DATE	Jul 24, 2018
SHEET	1
PROJECT NUMBER	18087

Conceptual Site Plan

AMEDSON PRE-PLAT

# Markup Summary

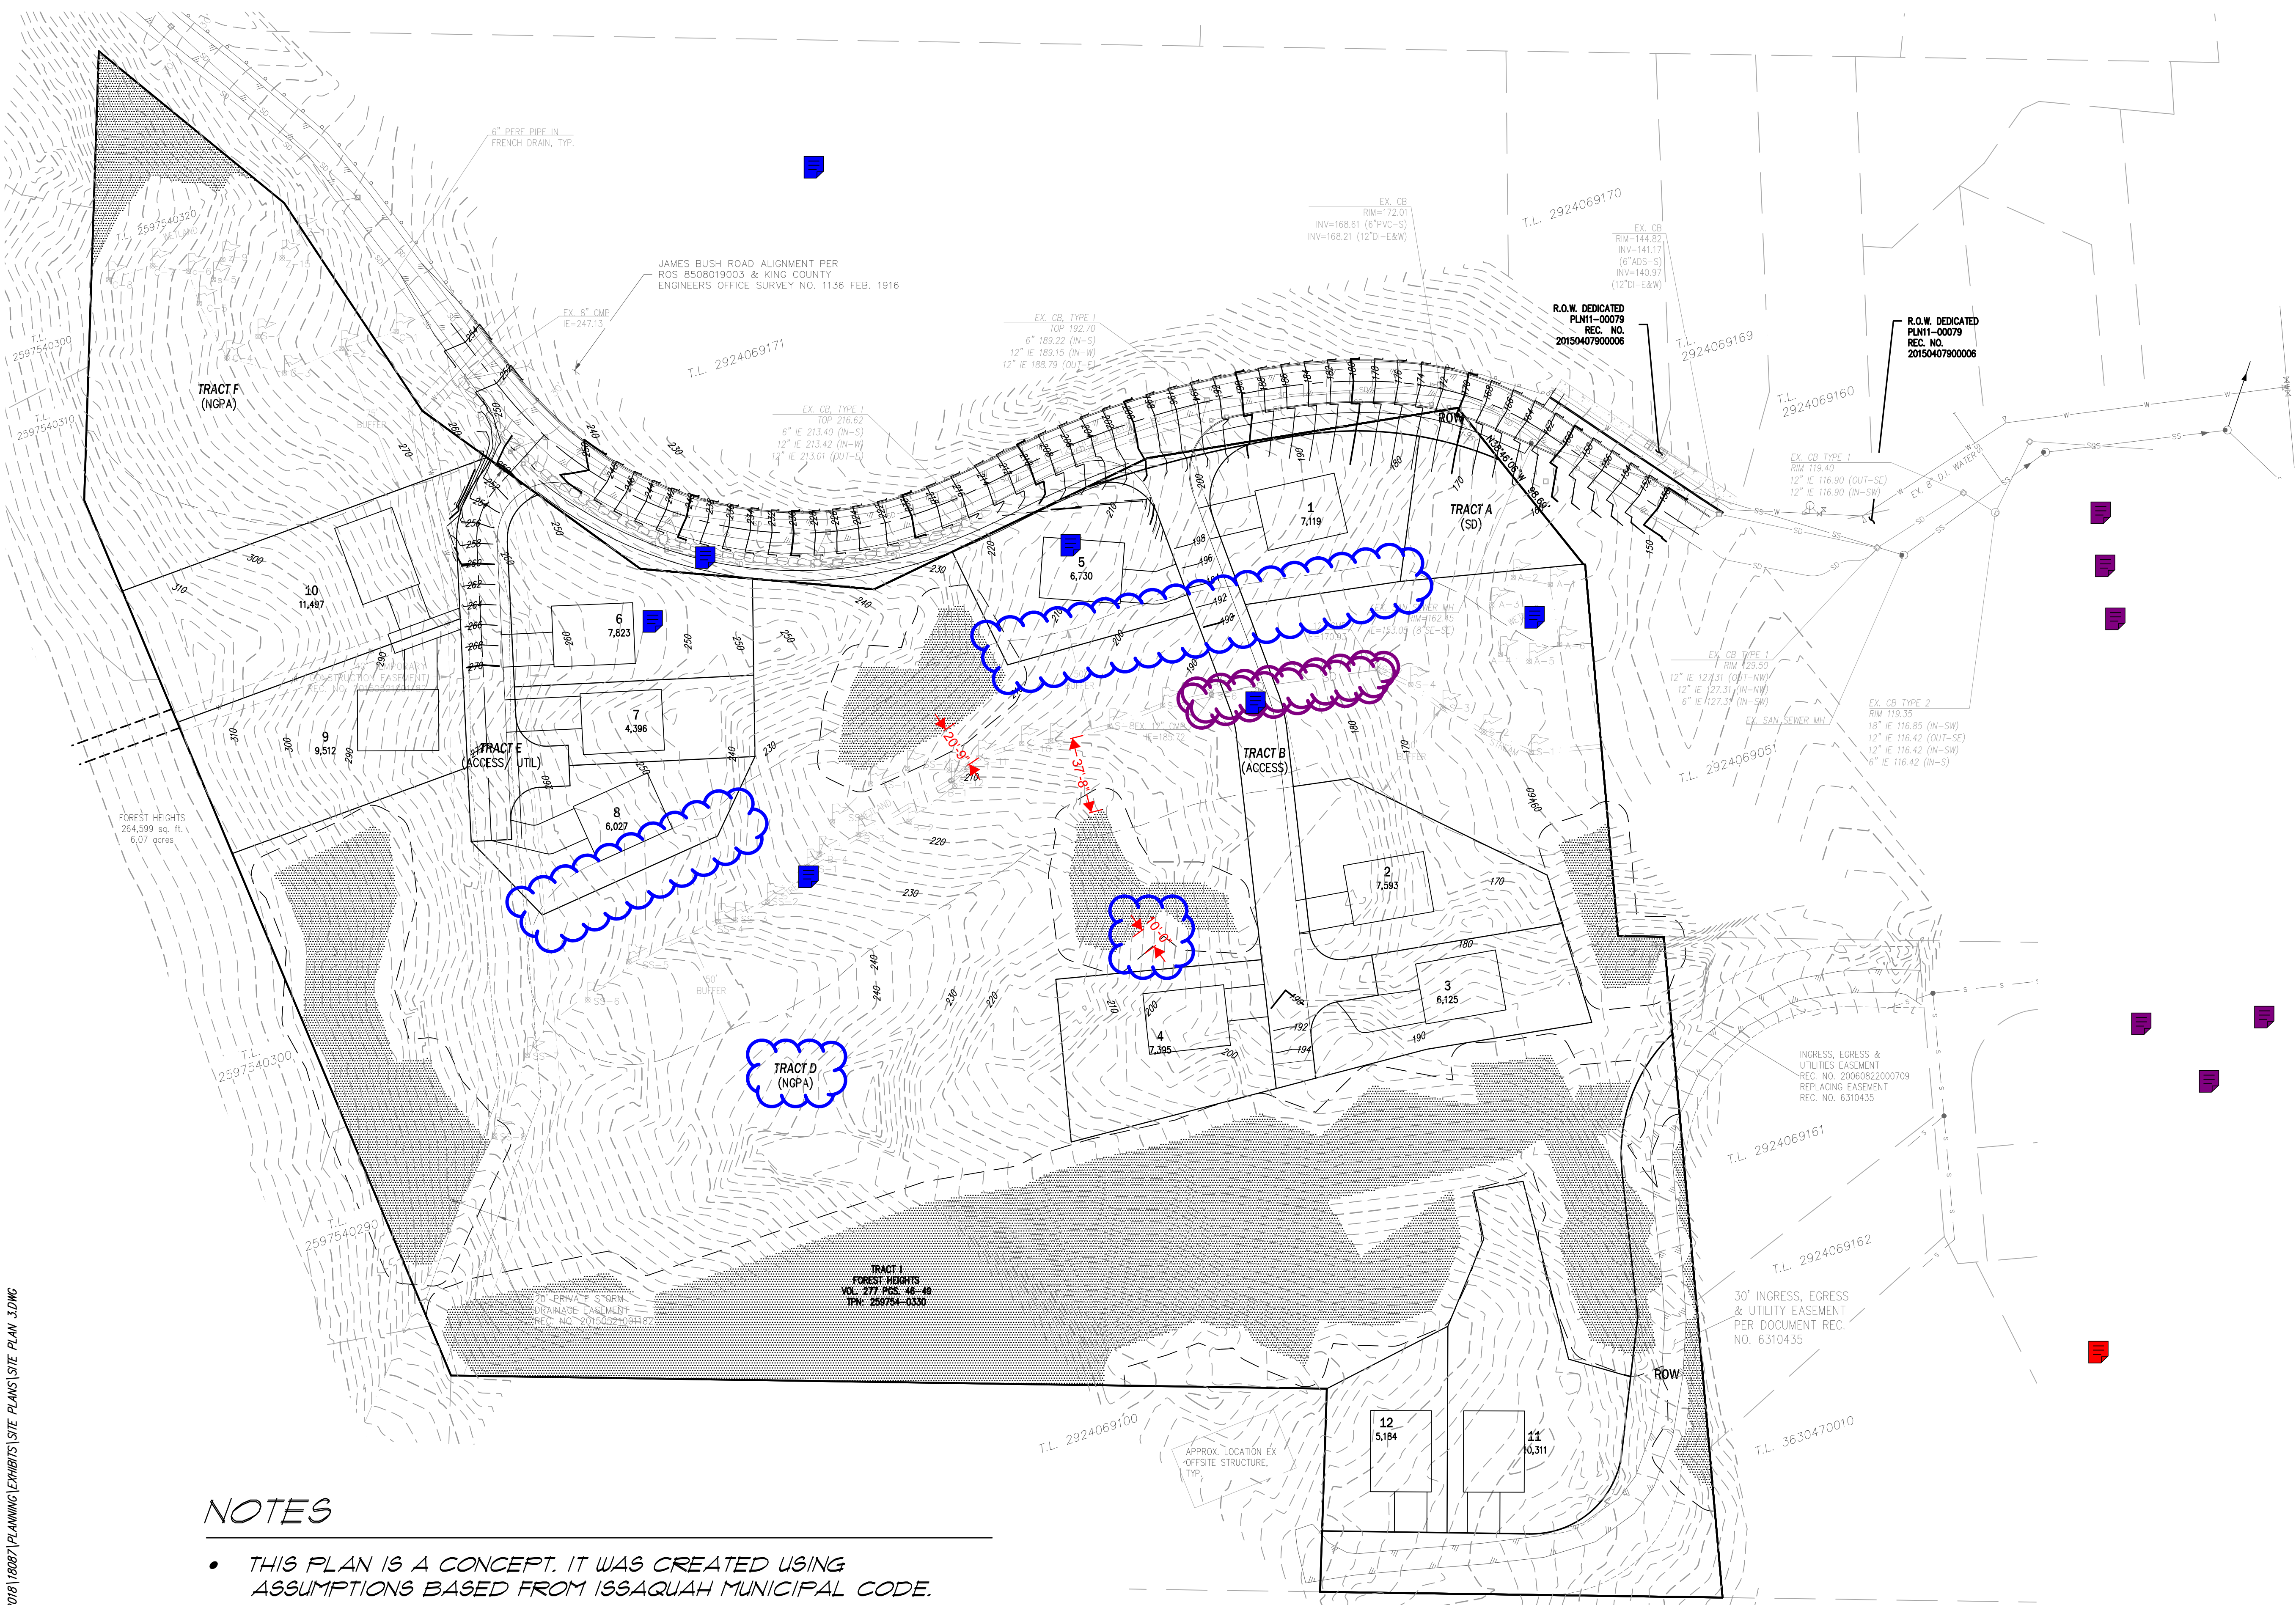
Given fire hydrants are required, PRV may be needed for water main.

A Construction Storm Water General Permit (CSWGP) from WA State Dept. of Ecology is required for land disturbing activities 1 acre or greater.

Home needs to be located outside of the 15-foot BSBL.

Impacts to the stream buffer by the road and crossing require mitigation. This will be reviewed in a subsequent site-work permit.

Steep slope buffer reduction requires a geo-technical report to determine if slope is stable enough for a reduced buffer. This requirement will be double peer-reviewed at applicants expense.

A PP and FP condition will be notice on title for steep slope buffer reduction and an agreement which indemnifies and holds the city harmless for development within 50-feet of a steep slope. This requirement can be found in IMC 18.10.580

Must demonstrate density calculation in critical areas found in IMC 18.10.450 to reduce the lot sizes below the minimum for SF-S zone (9,600sf).

Be advised lots must comply with the impervious surface limit of 40%.

2-foot clear zone between rock wall and ROW.  
Guard rail along sidewalk.

James Bush Road will need road frontage improvements

Applicant required to provide Level 1 Downstream Analysis.

- 1) James Bush Road
  - a. Need 2ft clear zone from face of rockery to drive lane
  - b. Street lights required
  - c. Pedestrian crossing needs to be placed to ensure sight distance
  - d. Fall protection required if sidewalk is allowed on top of rockery
- 2) ESFR
  - a. Hammerheads need to meet ESFR requirements
  - b. Fire trucks will drive maximum of 150ft and the back-up, fire hose must reach all sides of structure 150ft maximum
- 3) Water System
  - a. Two pressure Zones 297 and 616
  - b. Fire Hydrants in 616 development area may require main extension down James Bush Road
- 4) Storm – Ecology 2014 manual and Issaquah addendum
- 5) Lots 11 & 12
  - a. 616 zone
  - b. Access improved with 20ft road and sidewalk

Stream buffer needs to be included in NGPE and home needs to be outside of BSBL.

Stream buffer may be reduced if it qualifies under IMC 18.10.790.D.4.b(1)(A-C)

No street or utilities shown on plan set to comment too.

Fire turnarounds not approved. See fire turnaround requirements in Trakit attachments.  
Onsite fire hydrants will be required.  
Fire sprinklers will be required.

Submit wetland report with rating form to verify wetland type and if it is regulated.

WA DOE has recently revised the habitat score for wetland type. However, COI has yet to adopt those revised numbers and will continue to use the numbers found in IMC 18.10.620 with corresponding buffer width in IMC 18.10.640.

NGPE shall be recorded with the Plat.

The existing culvert may need to be retrofitted for fish passage. This requires a culvert determination from WA Dept. of Fish & Wildlife and may require Hydraulic Project Approval (HPA).

Compliance with 2014 Ecology Storm Water Management Manual for Western WA and 2017 Issaquah Addendum to the City adopted storm design manual. This includes a Storm Water Technical Information Report demonstrating how all Minimum Requirements #1-9 have been addressed.

Stream buffer needs to be included in NGPE
